AVLI 01-03 Rev. 3
Resulting from the decisions taken during
the session of AVLI Editorial Task Force,
Brussels, 18 December 2013

Proposal for draft Supplement 6 to the 00-series of
amendments to Regulation No. 86 (Installation of lighting
and light-signalling devices for agricultural tractors)

Submitted by **the Chair of GRE Informal Group "Agricultural Vehicles**
Lighting Installation" (AVLI)

Direction-indicator lamps

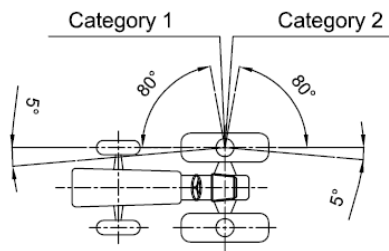
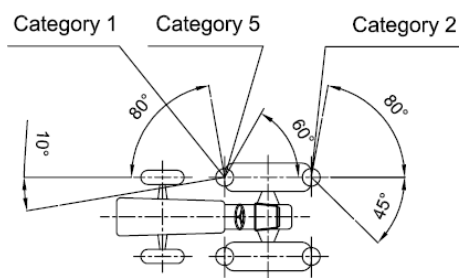
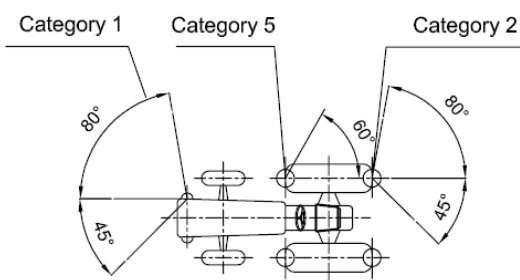
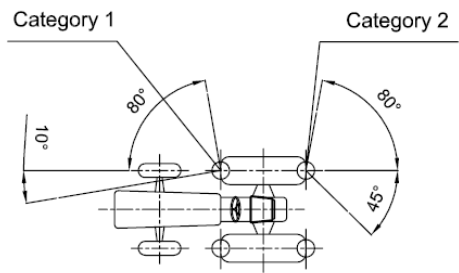
Annex 5 ((to be amended editorially according to 6.5.1, i.e add 1a or 1b after 1, replace 2 by 2ab in the figures))
